N9100A-03

S E R V I C E N O T E

N9100A 4080 series Parametric Test System

Industrial PC requires SATA digital cable and DVI extension cable to replace

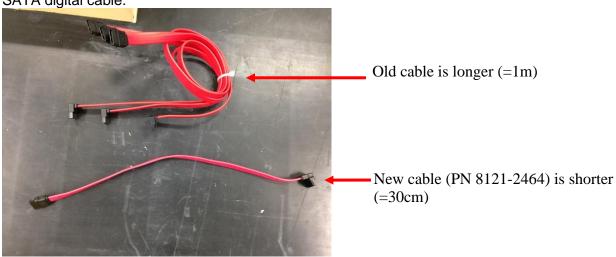
Agilent industrial PC includes SATA digital cables and bundle DVI extension cable.

These cables are provided by same vendor with SATA power conversion cable that should be replaced as Service Note N9100A-02.

Though these cables don't have manufacturing problem, but Agilent offers to replace.

Remove industrial PC from system cabinet, and replace PN 8121-2464 SATA digital cables (x 3ea) and PN 8121-2649 DVI extension cable.
